Offshore Electricity Transmission: Technical consultation on changes to industry codes for the enduring regime. Annex 2: Grid Code

Document type: Annex

Ref: Insert reference DECC URN10D/976 Ofgem ref 137/10

This document sets out our proposed amendments to the Grid Code that we consider necessary to implement our proposals.

Figure 1

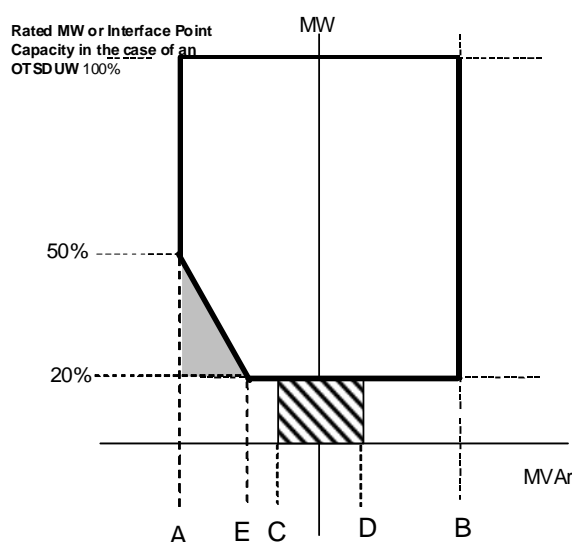
¹ Please note that Figure 1 has an unmarked change in the title of the table.

Figure CC.A.7.2.2a

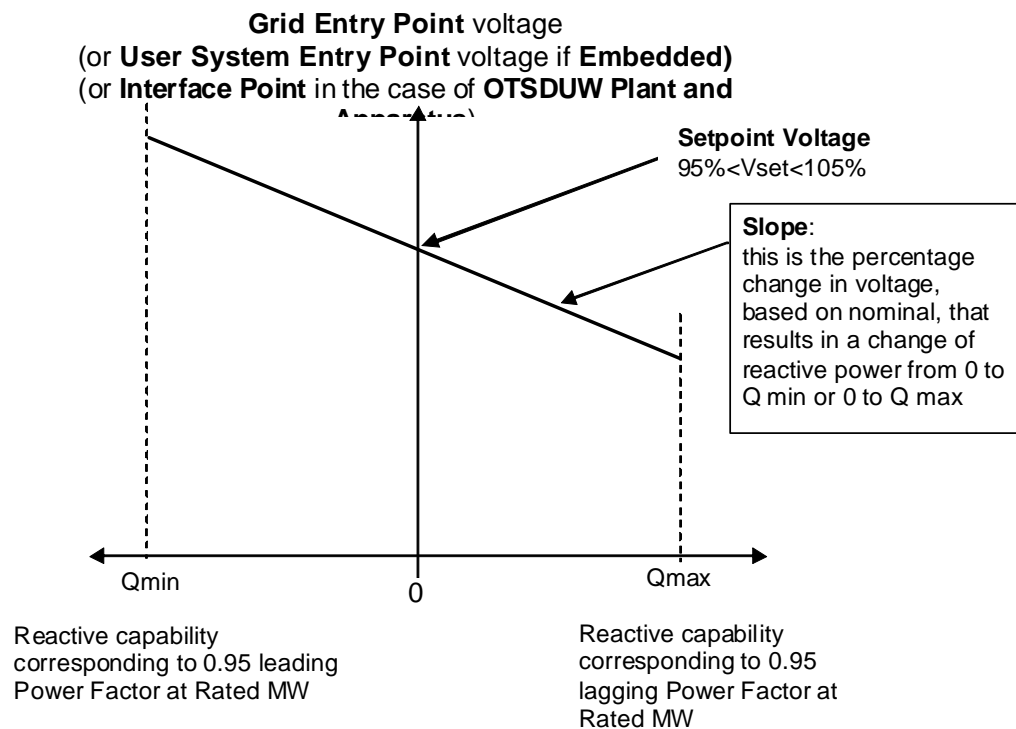
² Please note that Figure A.7.2.2.a has an unmarked change.

Figure CC.A.7.2.2b

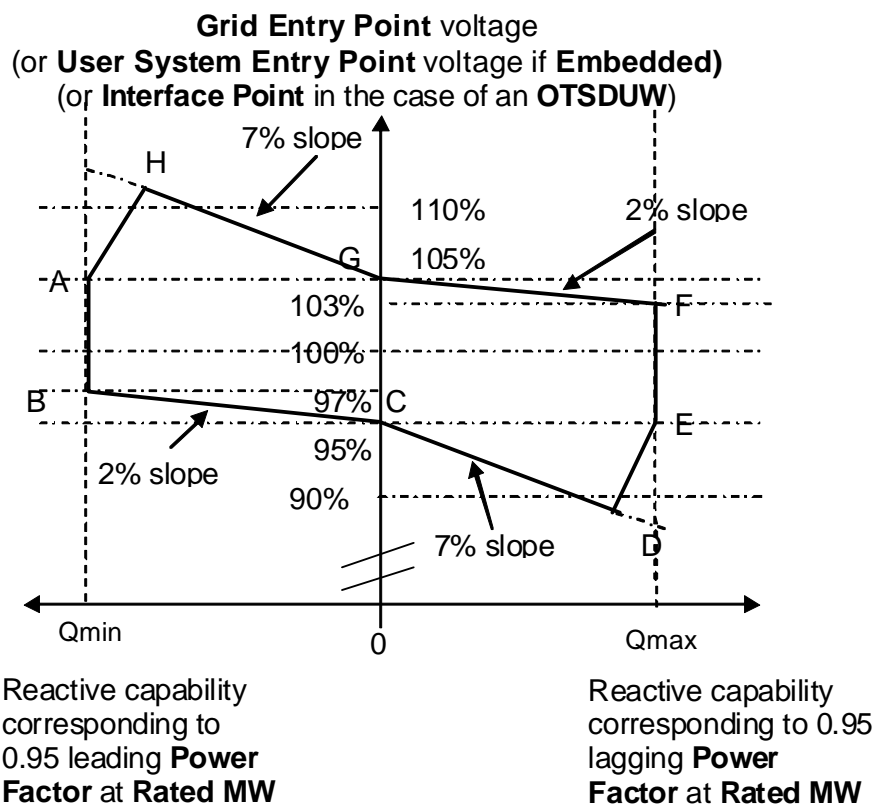
³ Please note that Figure A.7.2.2.b has an unmarked change.
